RACE CODE
METHODOLOGY AND VERIFICATION

Additional Information in Response to Question 1.

FIGURE 1.10

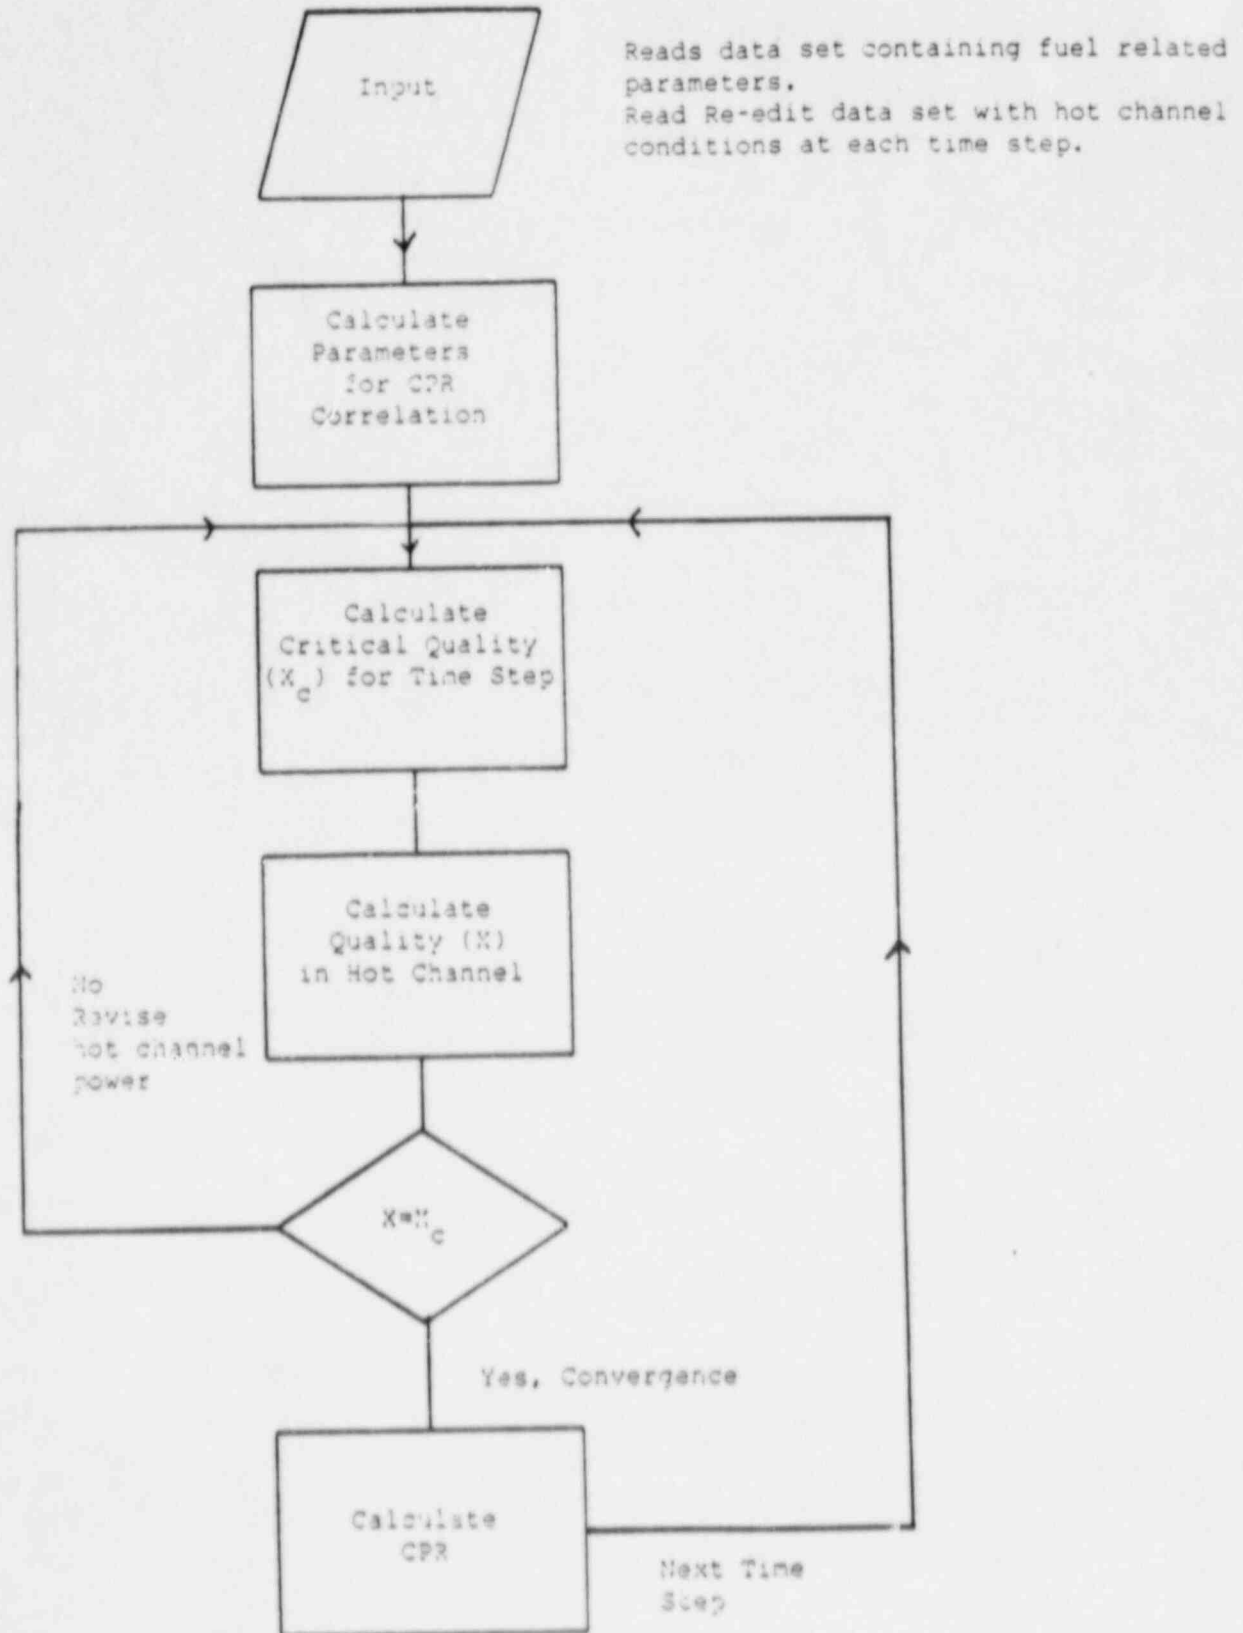
Figure 1.10 is a simplified flow diagram of the RACE code. RACE utilizes the same bundle power and axial power shape used in the hot channel. The hot channel data is read and CPR is calculated at each time step. The code determines initial CPR, minimum CPR and the maximum change in CPR ($\Delta\text{CPR} = \text{ICPR} - \text{MCPR}$).

Figure 1.11

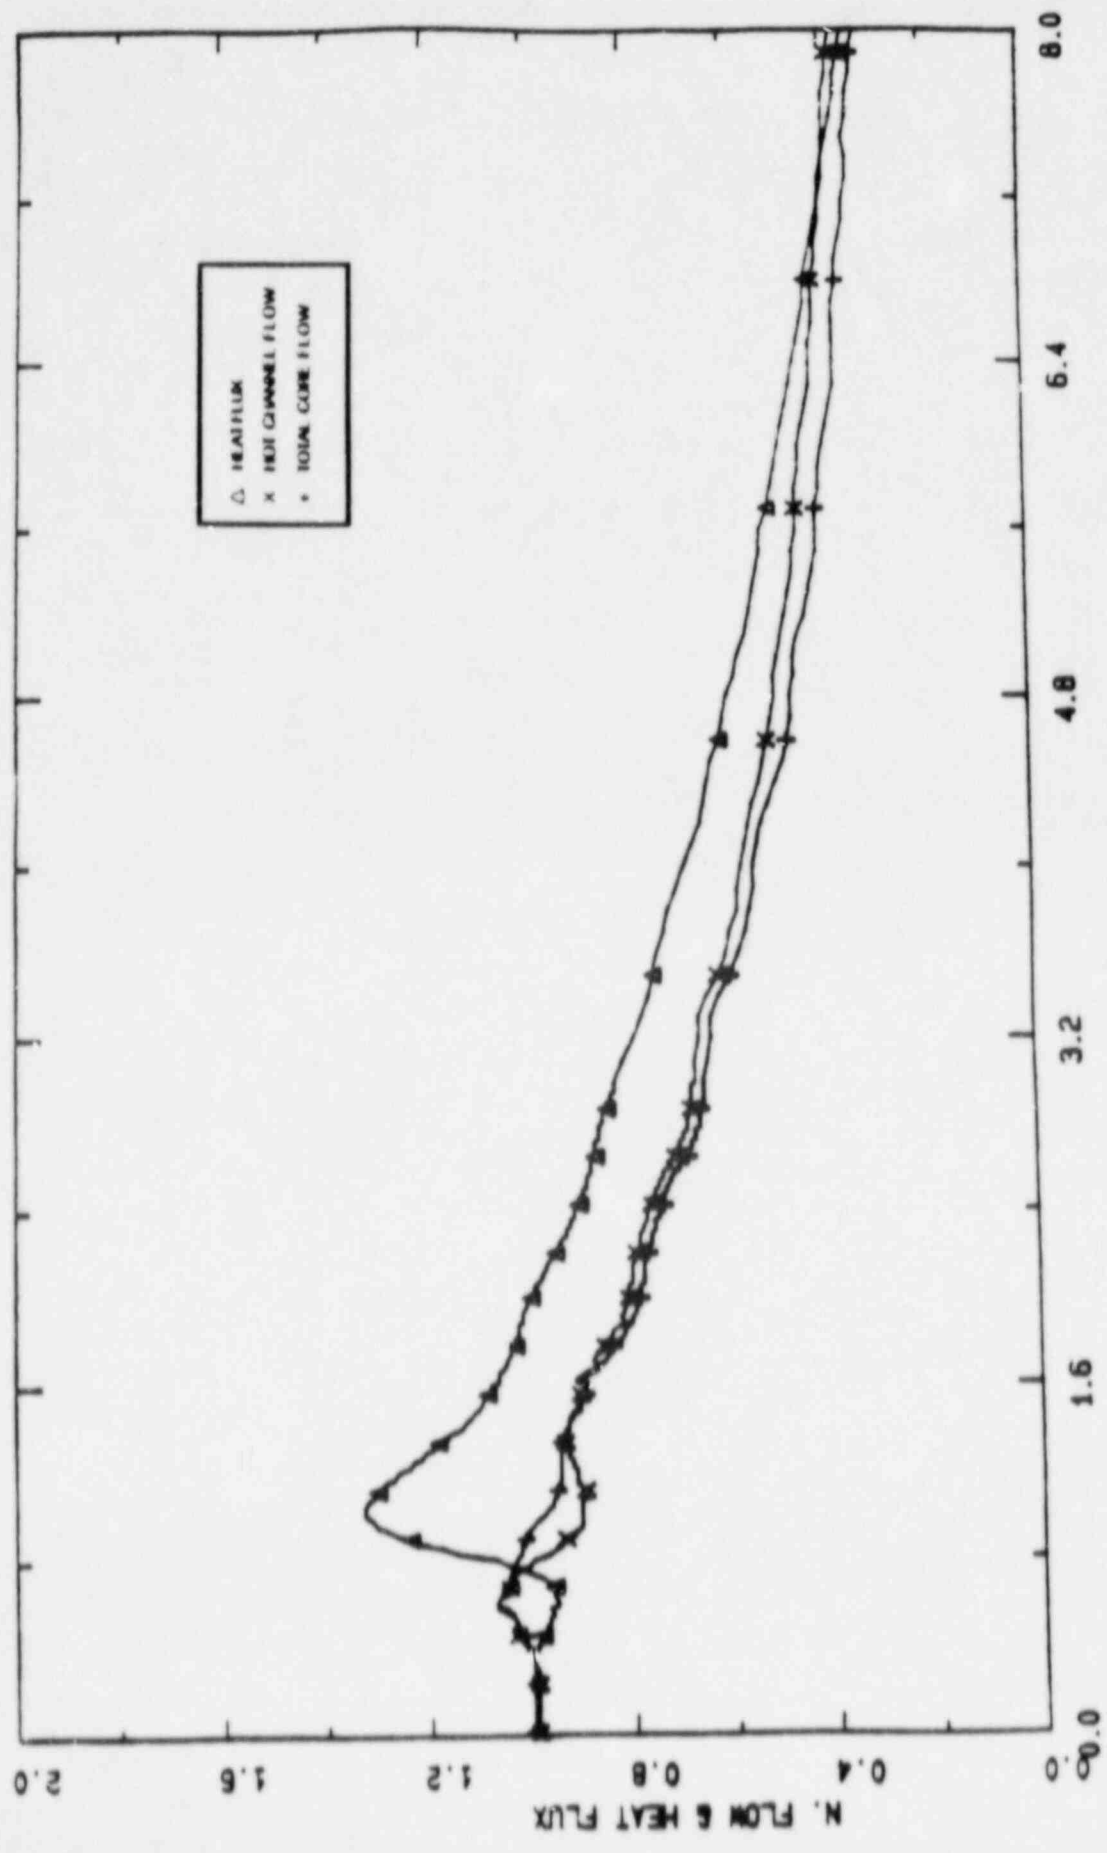
The differences between ODYN/SCAT and ODYN/RACE results are attributed to using the core average flow instead of the hot channel flow as stated in the RACE supplemental documentation. To further support this argument, a plot (figure 1.11) of hot channel flow, total core flow, and heat flux normalized to 1.0 shows that at peak flux, the hot channel flow is less than the core average flow (hence lower CPR with hot channel flow). Therefore, the use of a fixed hot channel flow as a fraction of total core flow would be non-conservative and explains the results of the ODYN/RACE vs. ODYN/SCAT comparisons. Later in the transient the normalized hot channel flow is greater than the normalized core flow as we discussed in the July 21, 1988 meeting.

Figure 5.1 - Total Reactivity and Neutron Power

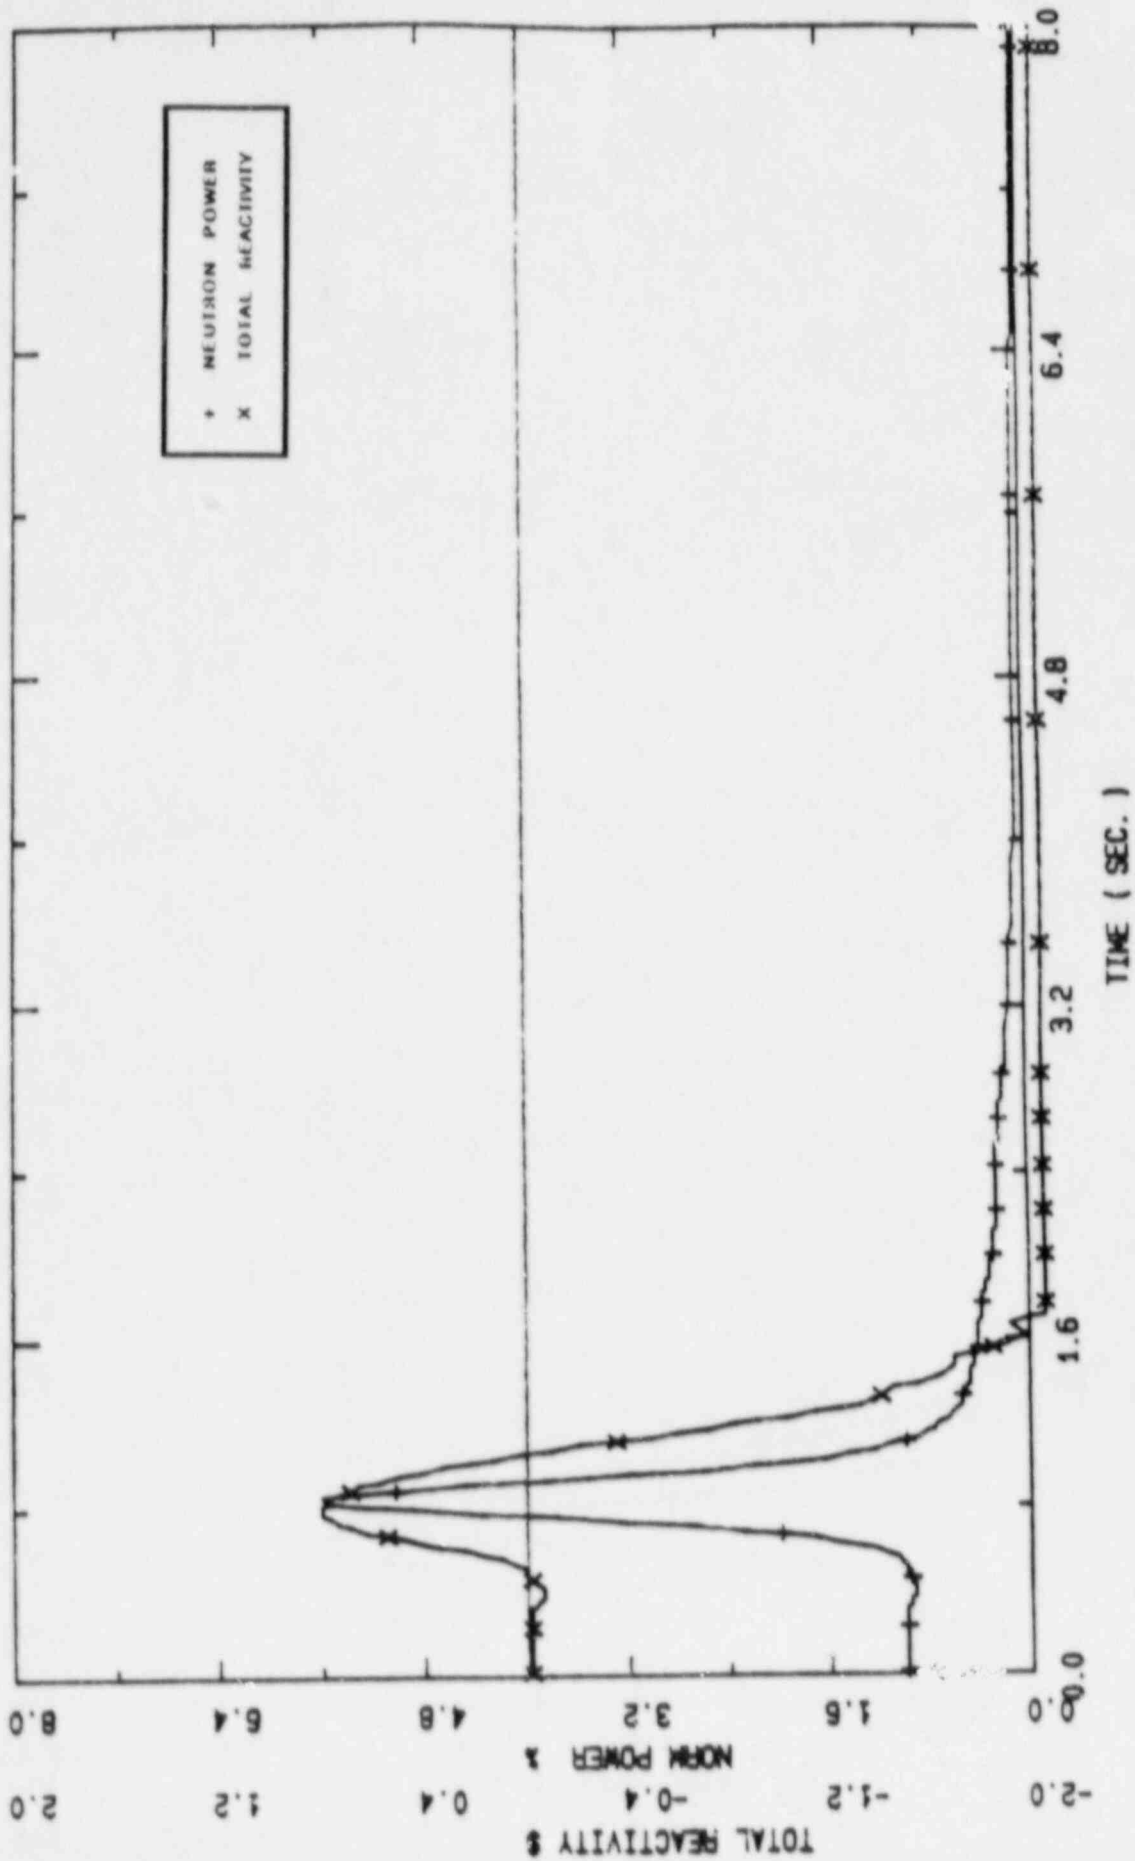
Figure 5.1 shows total reactivity and power vs. time. This total reactivity will start to turn around once the scram reactivity dominates the transient (it is not possible to plot the reactivity components for one-dimensional kinetics under MOD4). Many processes contribute to the core reactivity. The first and most important is void collapse due to the fluid compression produced by the pressure wave thus causing a power increase. This power increase immediately starts to put heat into the coolant via the direct moderator heating phenomena which is faster than conduction, causing additional void formation which tends to mitigate the transient (this effect was demonstrated during the sensitivity analysis). The fluid compression phase is then followed by a rarefaction phase as the pressure wave oscillates thus reducing the positive reactivity due to the compression as more voids are produced. The doppler effect is generally regarded as having a small effect because of fuel time constant involved. Once the control rods start inserting past the first couple of nodes the scram reactivity will dominate and turn the transient around.

Figure 5.2 - Pressure Wave Oscillations / Amplitude at Steam chest and Steam line

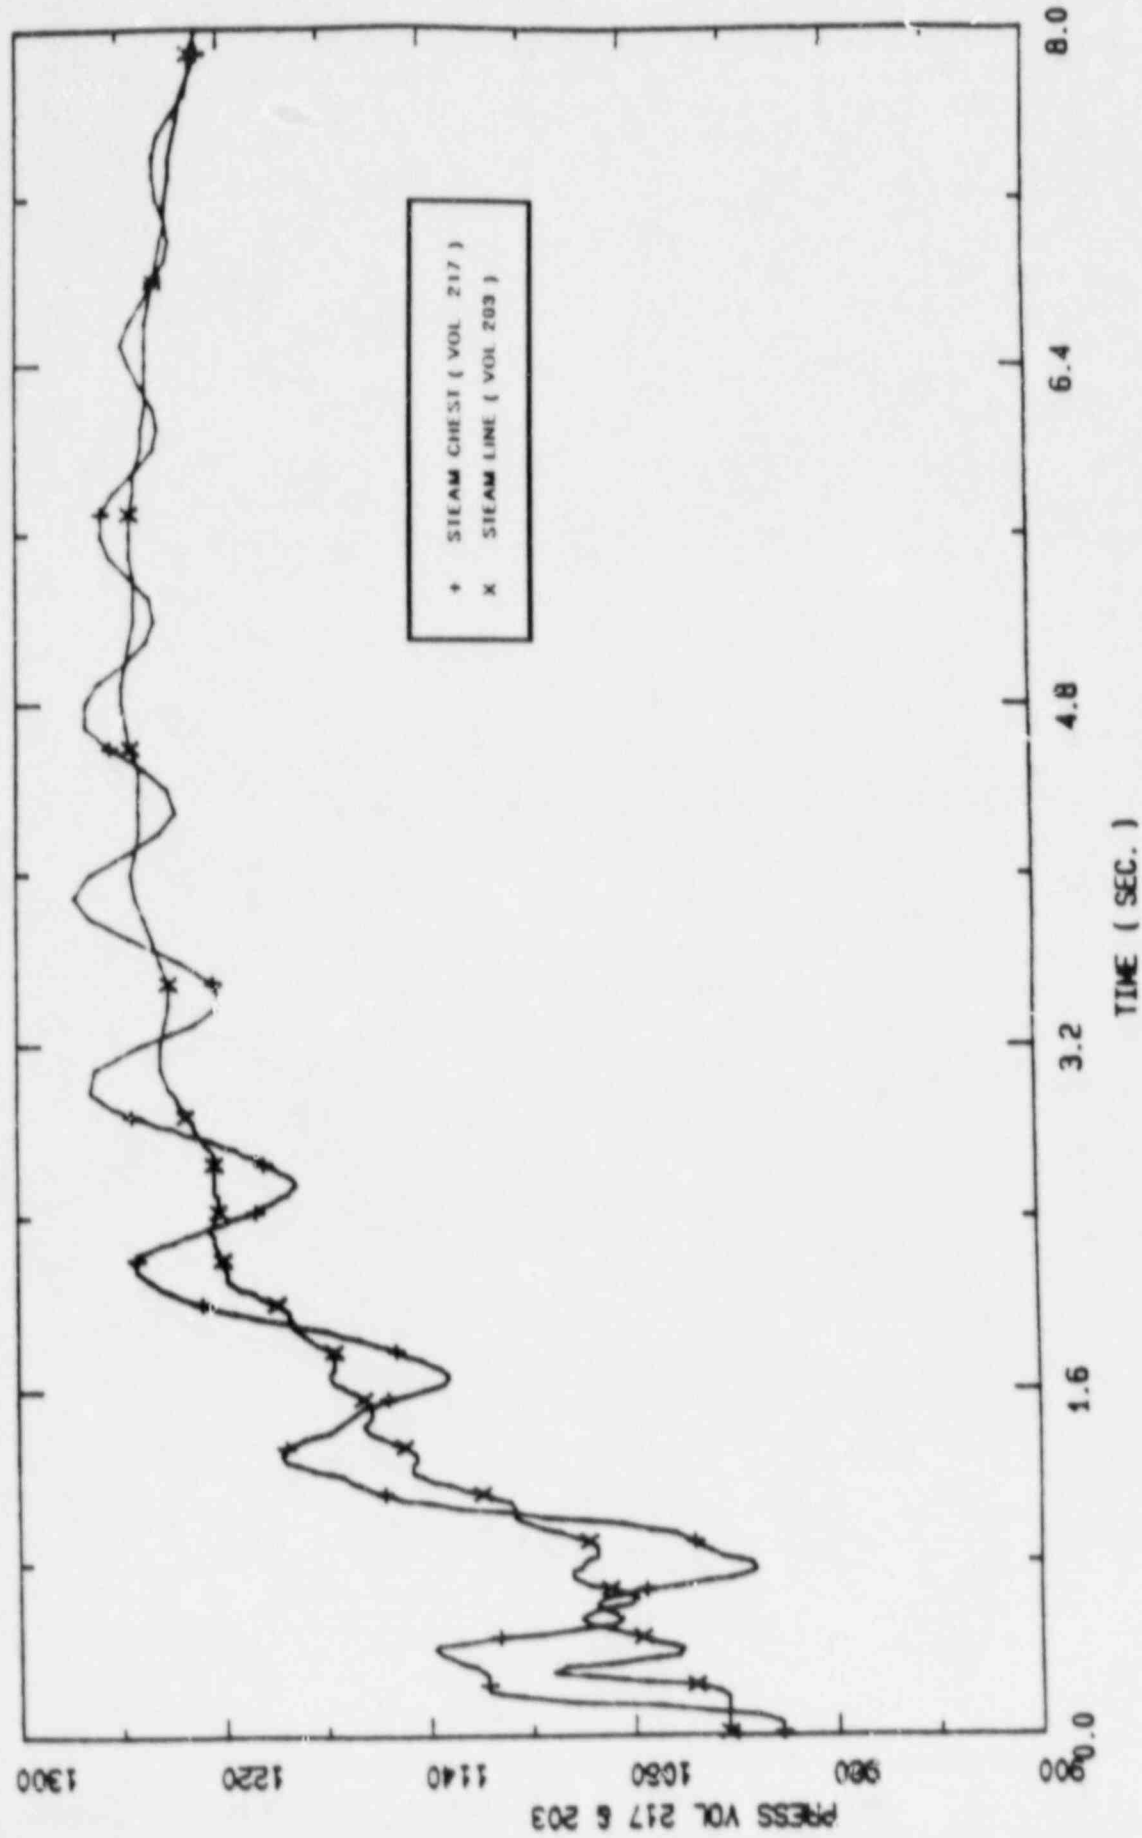
Figure 5.2 shows pressure behavior at steam chest (Vol. 217) nearest the Turbine Stop Valve where the high amplitude pressure wave produced due to valve closure is clearly seen. As the pressure wave travels along the contours of the steam lines, it gets attenuated and the pressure behavior in volume 203, which is close to the vessel, shows the attenuation effects reflected in the wave amplitude.

Figure 5.3 - Effect of pressure wave on core Inlet / Exit flow

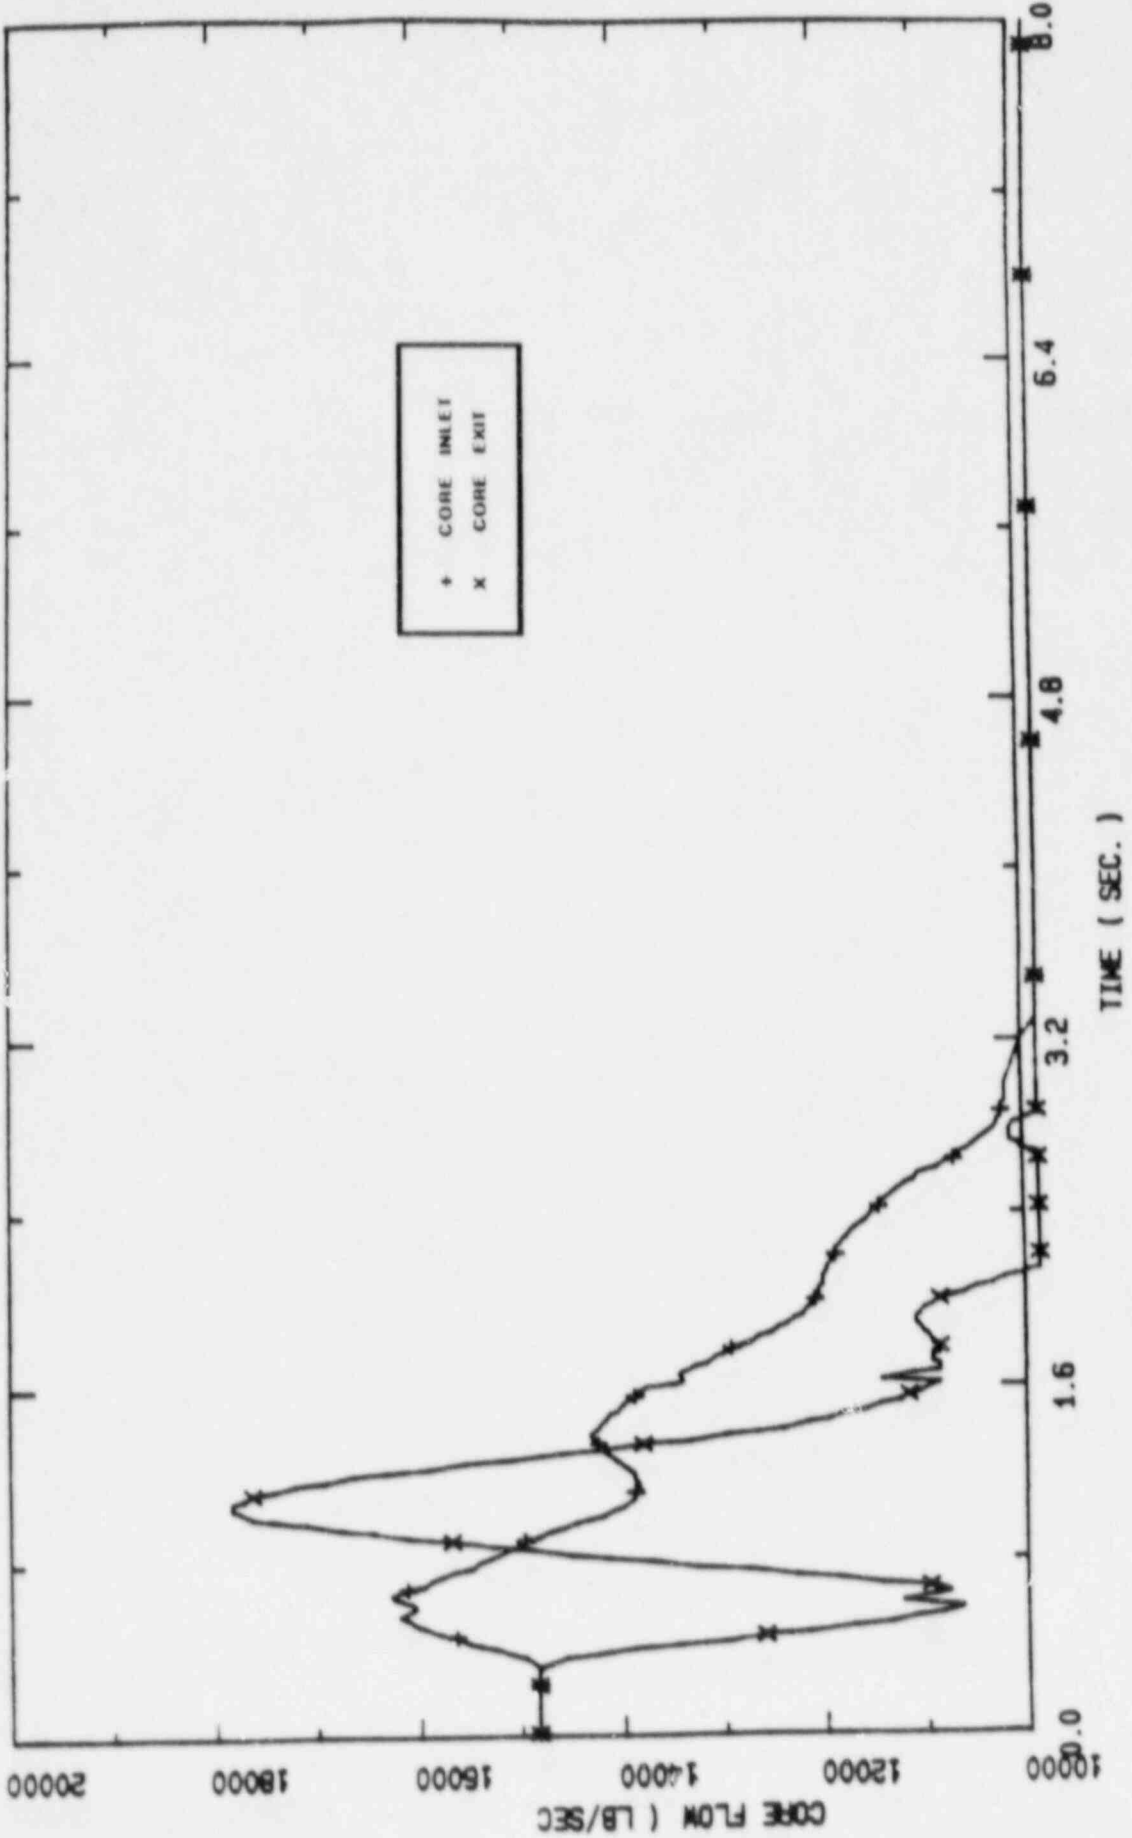
Figure 5.3 shows inlet and exit core flow during the early stages of the transient where an oscillatory component is clearly seen. The increase in inlet flow is due to pressure compression along the downcomer and recirc loop, in the direction of flow, while the decrease in exit flow is due to pressure compression along the separator, standpipe path which is against the direction of flow. The two compression effects are responsible for the fluid densification in the core as seen on average fluid density in different axial locations along the core, in Figure 5.4.
